RE: U.S. Patent: 7,109,659
Issued: September 19, 2006
Application Serial No.: 10/991,415
Filing Date: November 19, 2004
Applicants: Takeshi KAMOI
For: HIGH-INTENSITY DISCHARGE LAMP BALLAST
AND METHOD FOR OPERATING HIGH-
INTENSITY DISCHARGE LAMP
Group Art Unit: 2821
Examiner: VO, TUYET THI

REQUEST FOR CERTIFICATE OF CORRECTION

FIG. 4

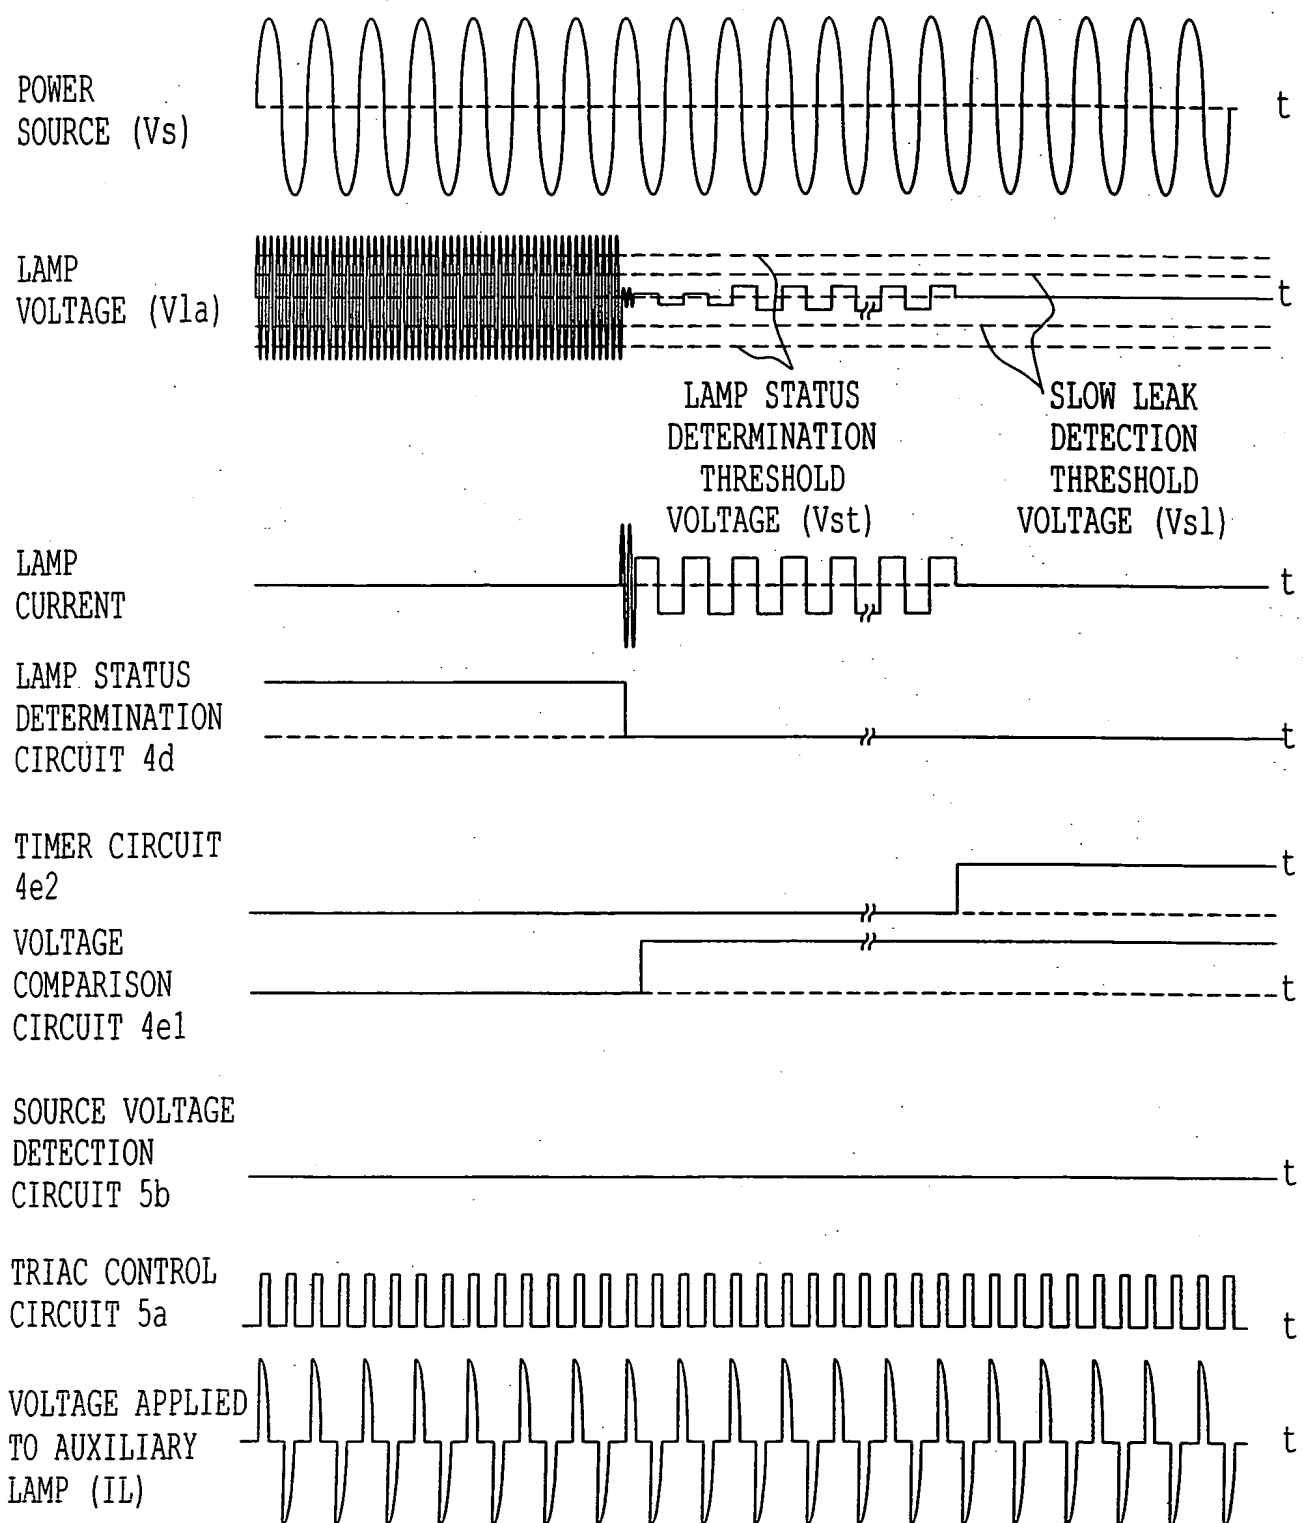
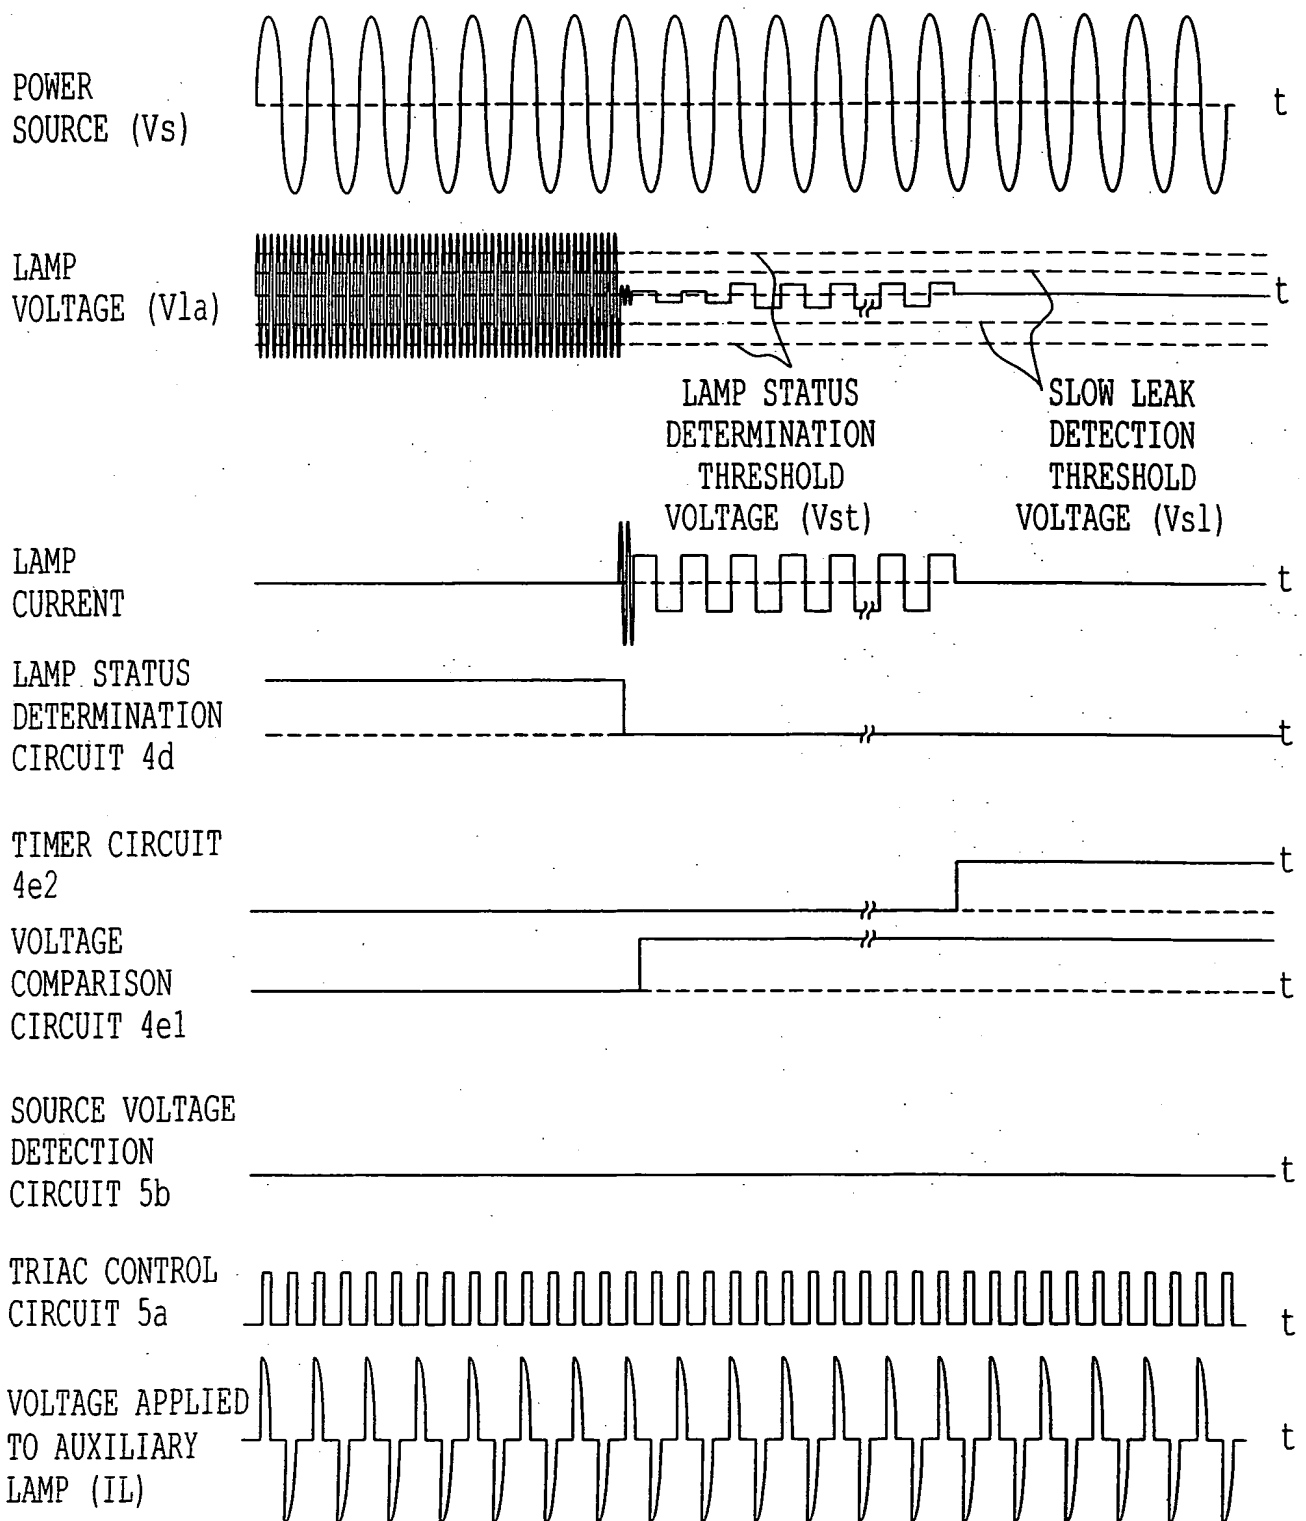
The '659 patent includes Figure 4 which is a sequence diagram showing an operation
of a high-intensity discharge lamp when a slow leak occurs in the lamp. The '659 patent
states in column 7, lines 37-67, as follows:

"In the case of FIG. 4, due to the slow leak in the HID lamp (La), the lamp
voltage (V_{la}) does not reach the threshold voltage (V_{sl}). When the time
measured by the timer circuit 4e2 exceeds the predetermined length of time
and the detected lamp voltage (V_{la}) is still lower than the threshold voltage
(V_{sl}), the slow leak detection circuit 4e determines that there is a slow leak in

the HID lamp (La) and switches its output from the L signal to the H signal. The switching circuit 4f2 receives this H signal and turns off the buck converter 2 to stop the power supply to the HID Lamp (La). *When the buck converter 2 stops supplying the power to the HID lamp (La), the lamp voltage (Vla) becomes substantially equal to zero.* The voltage comparison circuit 4e1 continues to output the H signal to the OR circuit 6, and thus the TRIAC control circuit 5a supplies the pulse to the TRIAC (Q51) to turn on the TRIAC (Q51). As a result, the auxiliary lamp (IL) remains turned on, receiving the effective voltage substantially equal to the rated voltage of the auxiliary lamp (IL) produced by the phase control of the source voltage (Vs).” (emphasis added)

However, the profile of the lamp voltage (Vla) in Figure 4 filed on November 19, 2004, is not consistent with the above descriptions in the ‘659 patent. Specifically, instead of reaching substantially zero as discussed in the specification, the lamp voltage (Vla) continues to increase in Figure 4. Therefore, for the purpose of clarification, Applicant respectfully requests that Figure 4 which appears in the ‘659 patent be replaced with corrected Figure 4 attached herewith.

Please replace Fig. 4 with the corrected Fig. 4 attached herewith.

Please replace Fig. 4 with the corrected Fig. 4 attached herewith.
